Addendum

DATE: 12/22/2023

PROJECT: 614, 624 & 702 Building Renovation and
Addition
East End Community Services / West Care

ADDENDUM NO. 1

DATE	12-07-2023
JOB NO.	4132.00
DRAWN	JLH
CHECKED	MSK
COPYRIGHT © 2022 - App Architecture, Inc.	
TITLE	LANDSCAPE PLAN

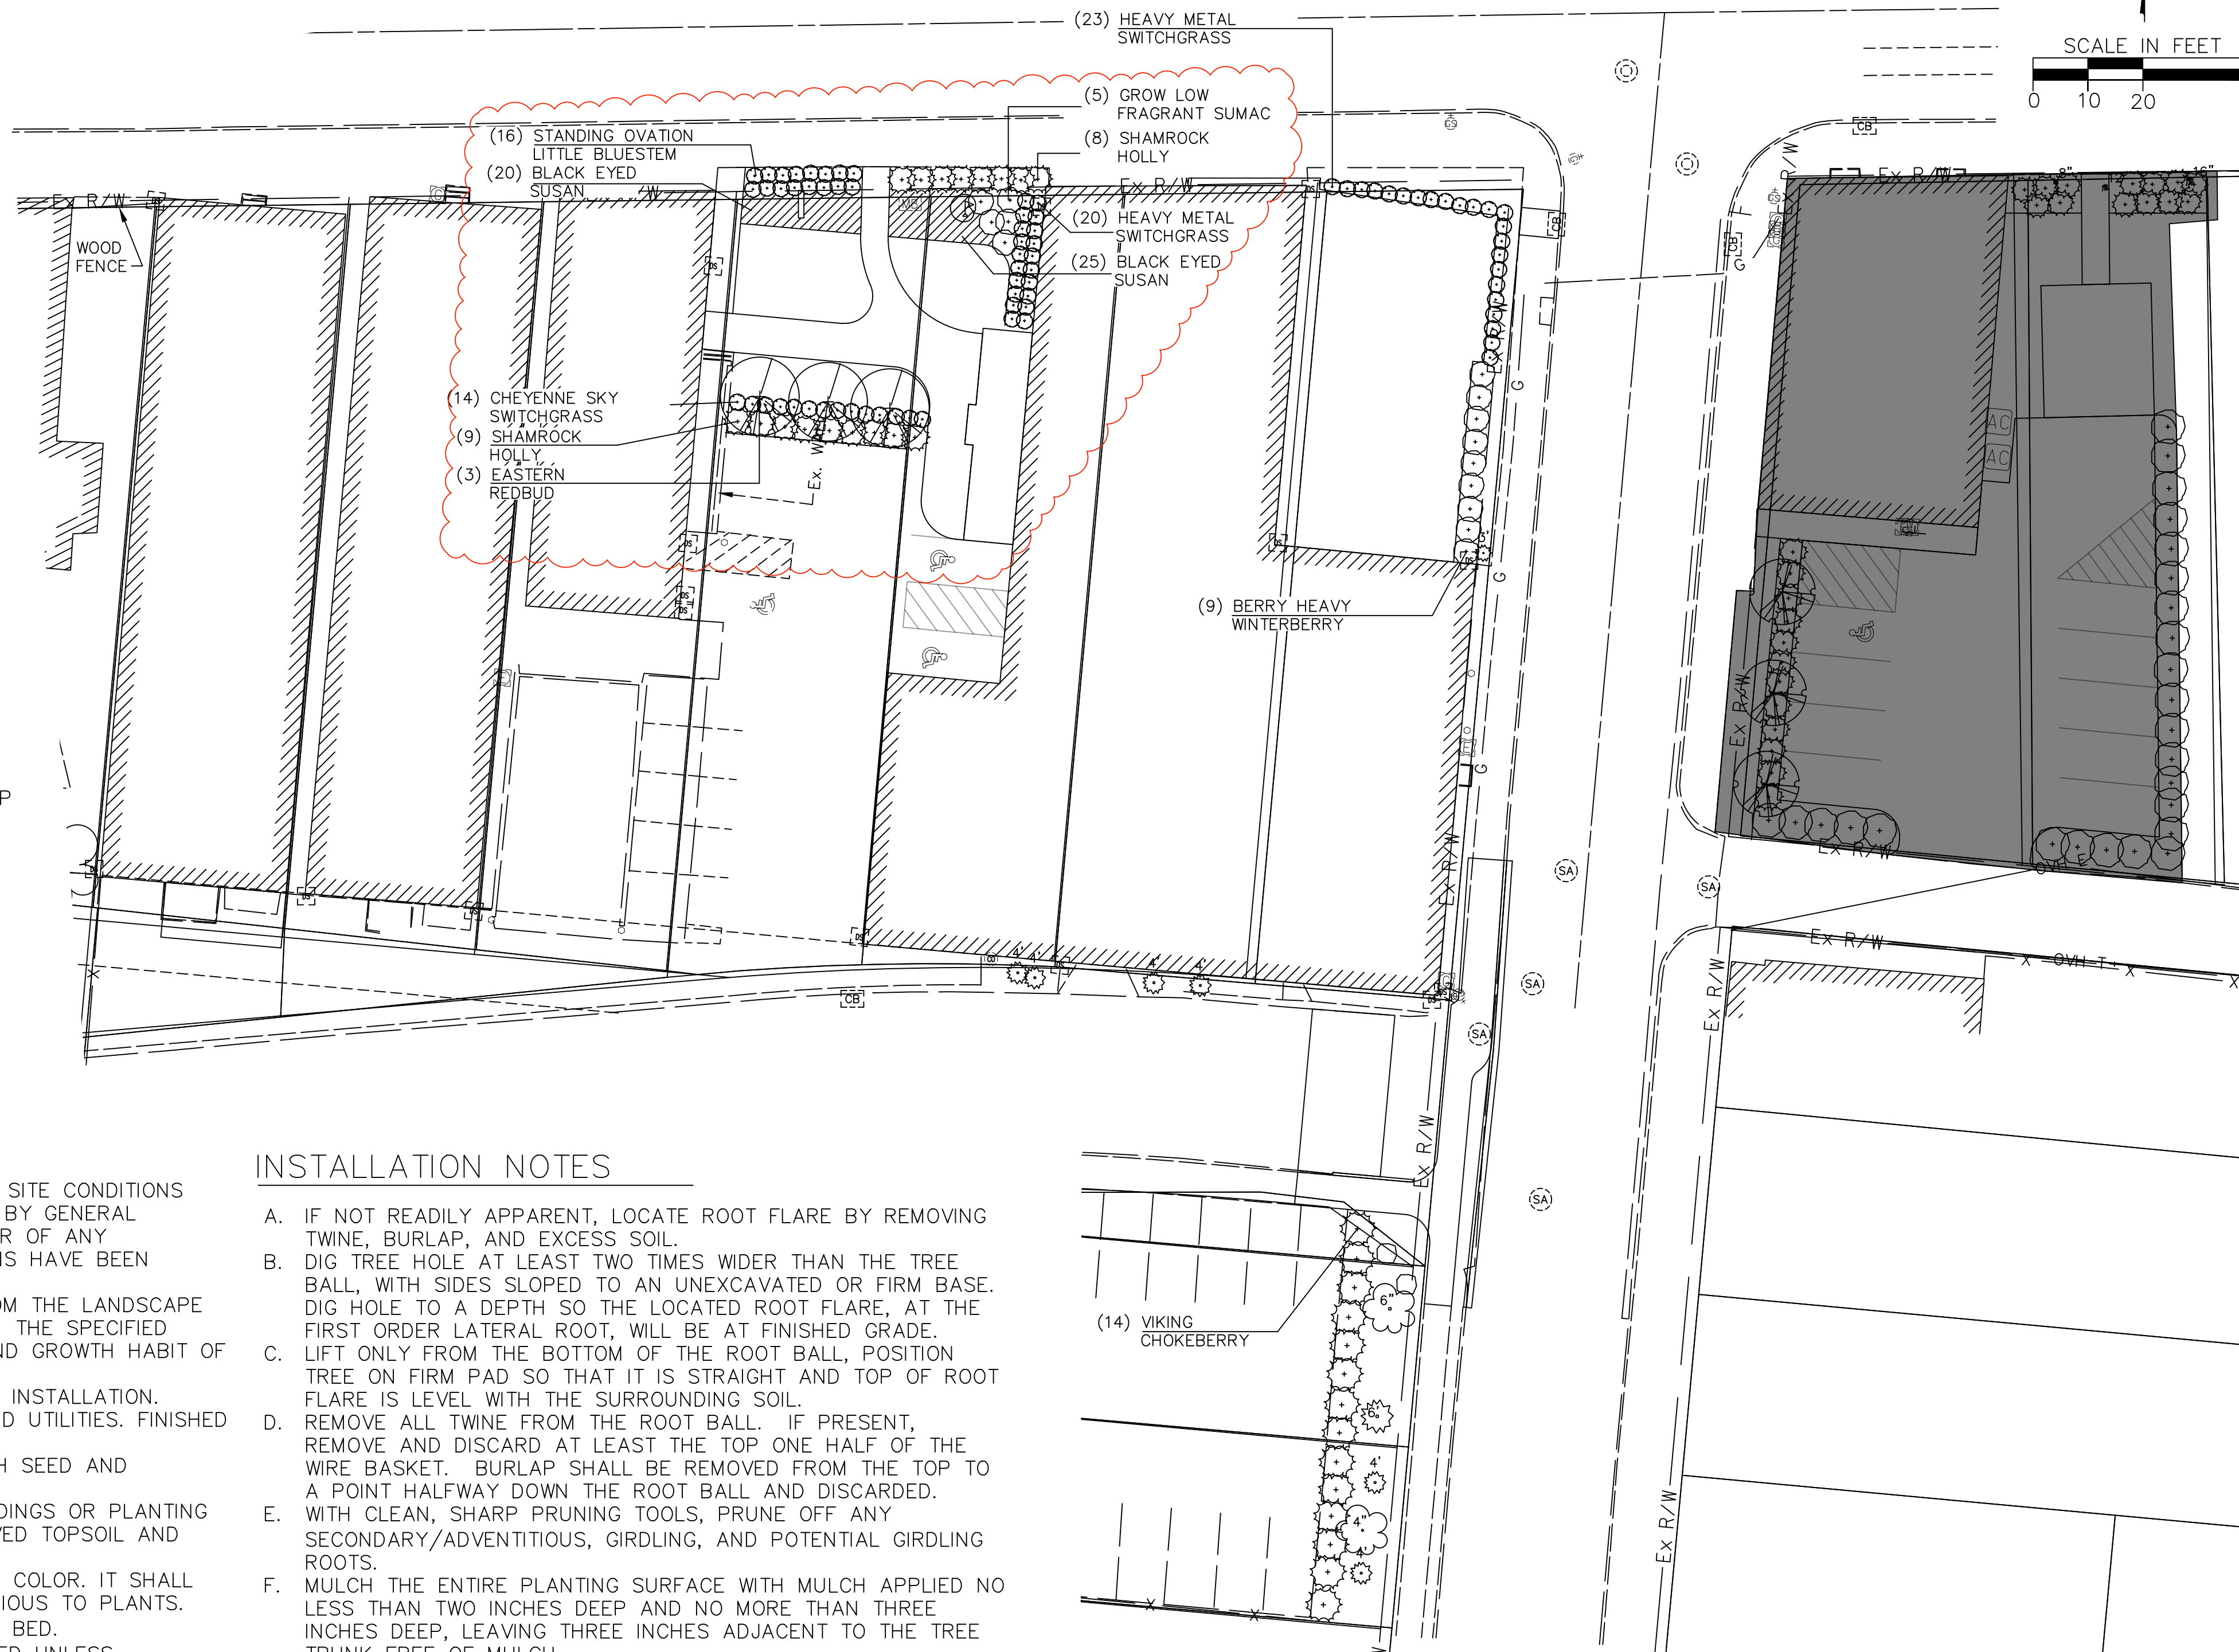
ITEM C1 SHEET C3.1 – LANDSCAPE PLAN (624 Building)
1. Revisions to landscape plantings

SHEET NO.
A1.3

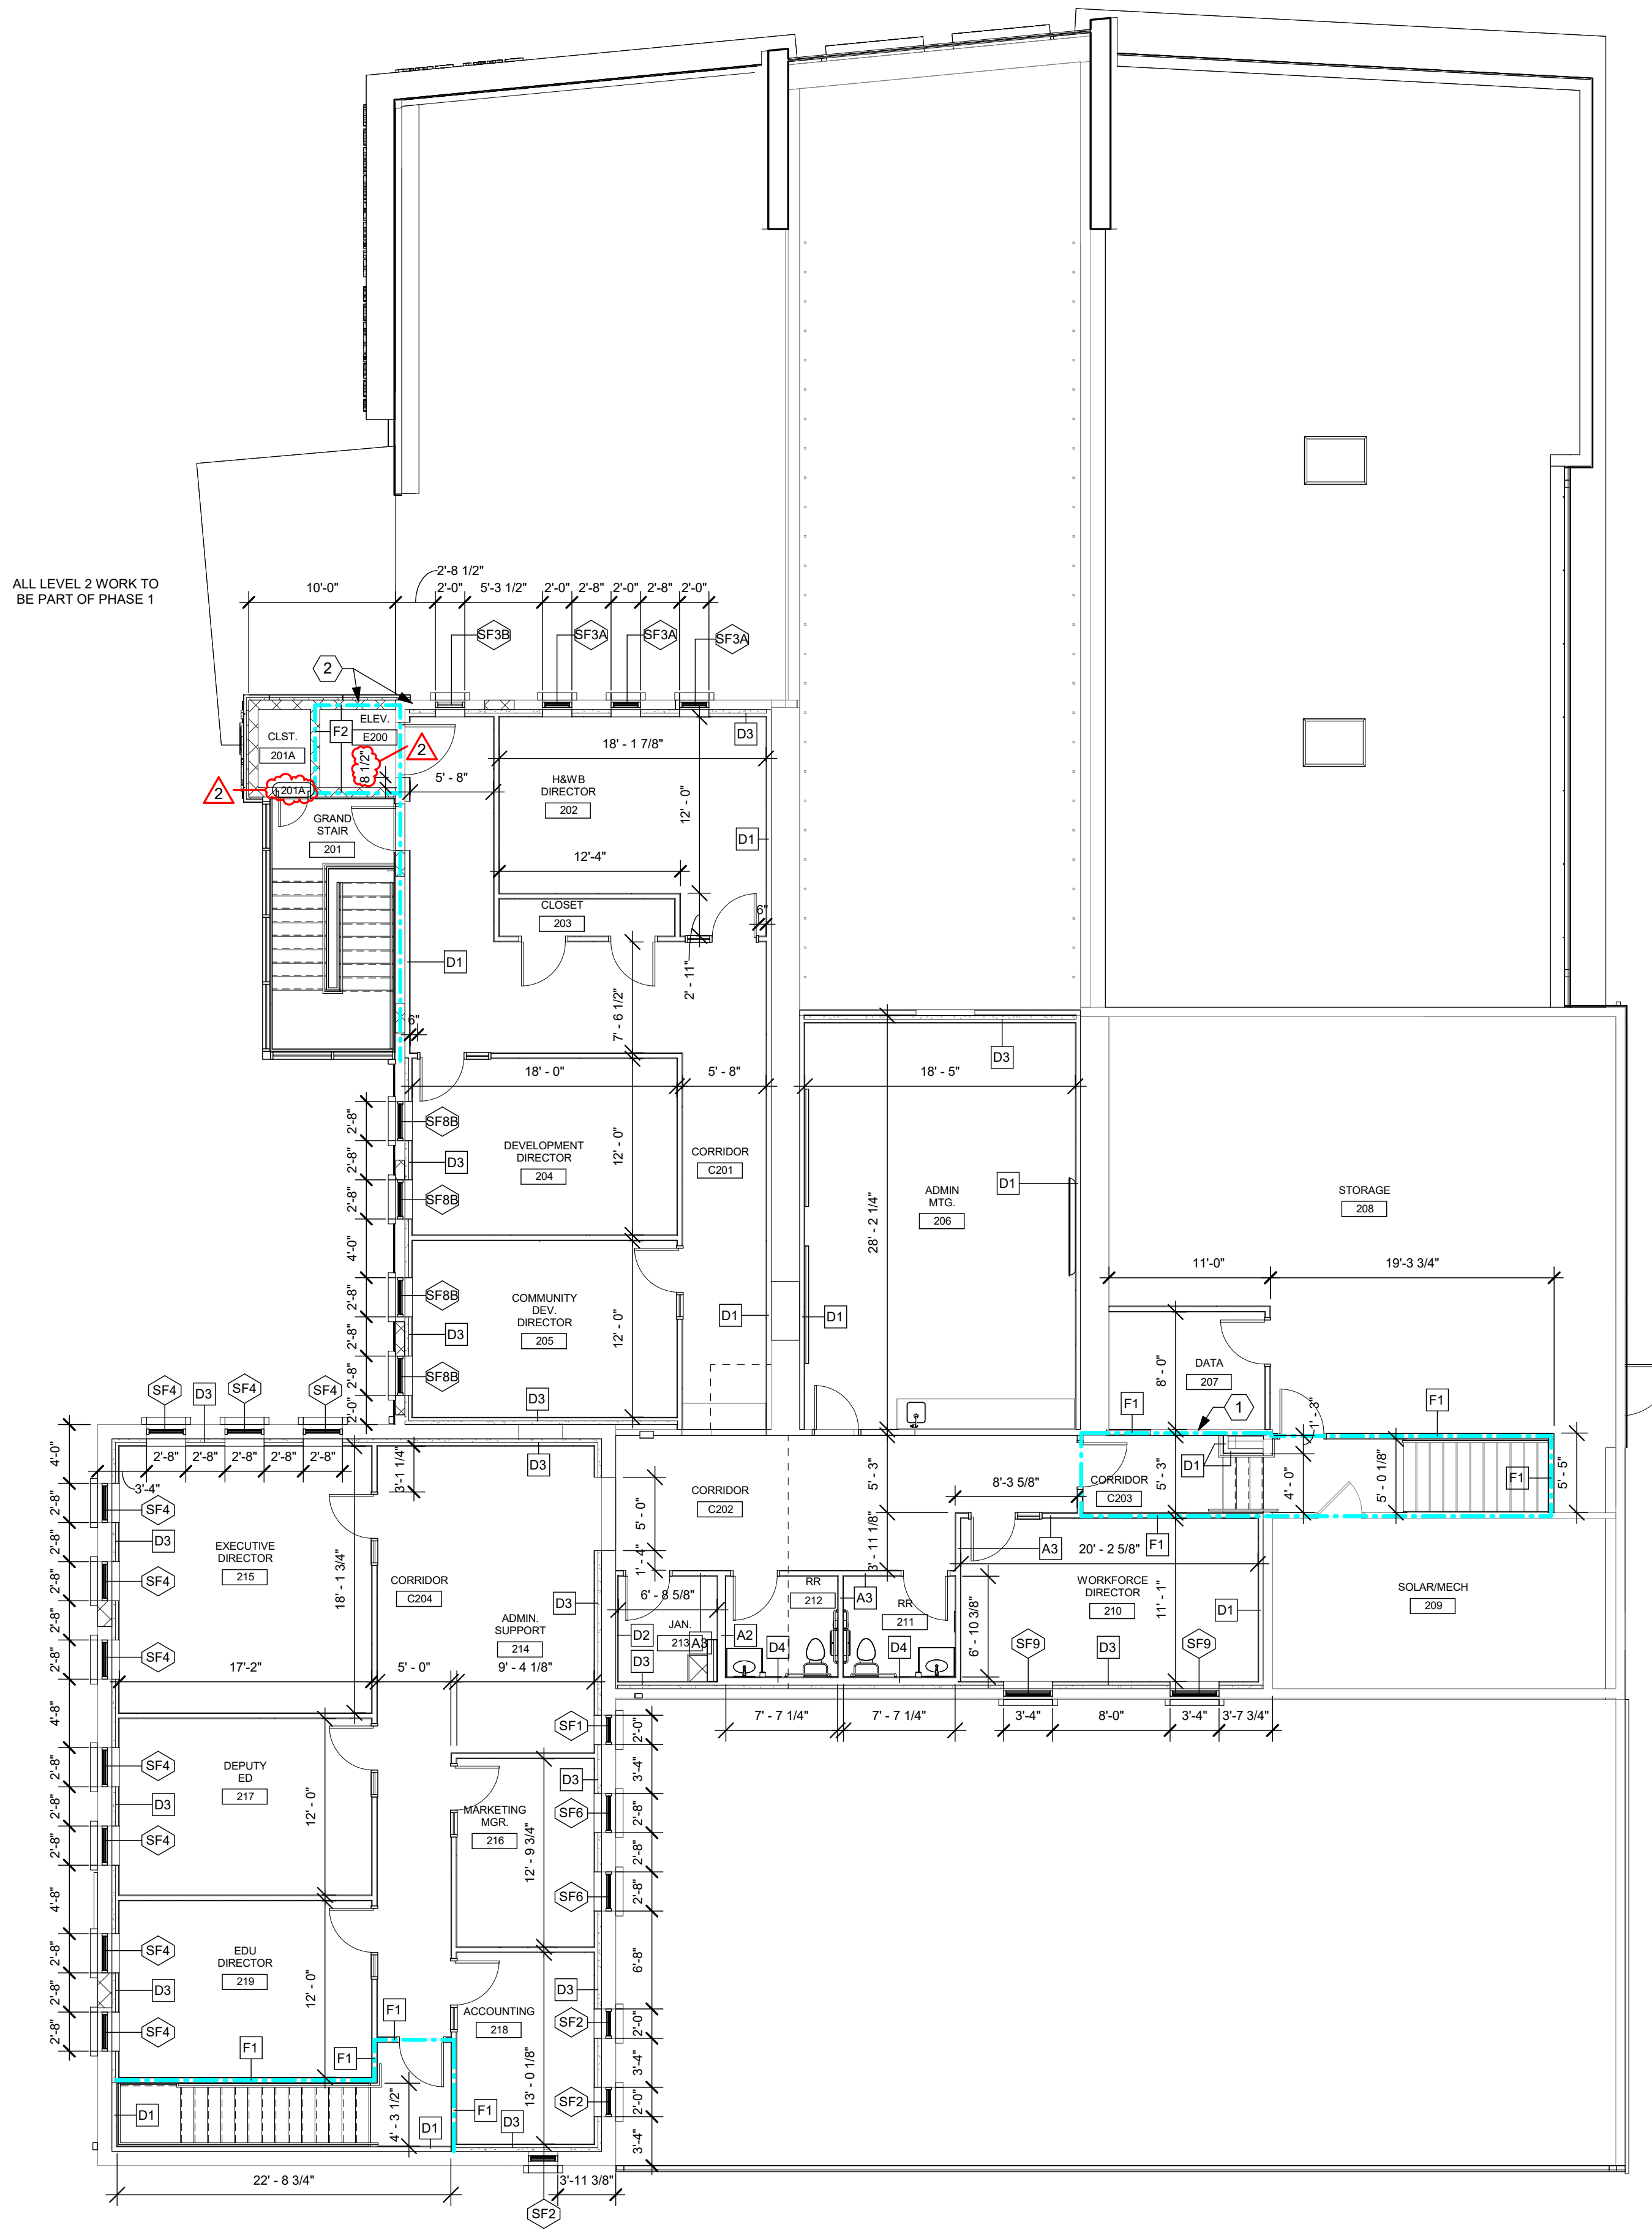
- ITEM A1 SHEET A0.3 – DOOR & FRAME SCHEDULES (624 Building)
 1. Doors 150 & 201A revised to 2'-0" wide doors.
- ITEM A2 SHEET A1.3 – FIRST FLOOR DIMENSION PLAN (624 Building)
 SHEET A1.6 – SECOND FLOOR DIMENSION PLAN (624 Building)
 1. Elevator shaft dimensions revised.
 2. Doors E100 & E200 locations revised.
 3. Doors 150 & 201A revised to 2'-0" wide doors.
- ITEM A3 SHEET A7.1 – INTERIOR ELEVATIONS (624 Building)
 1. Casework revised in Room 102 Receptionist.
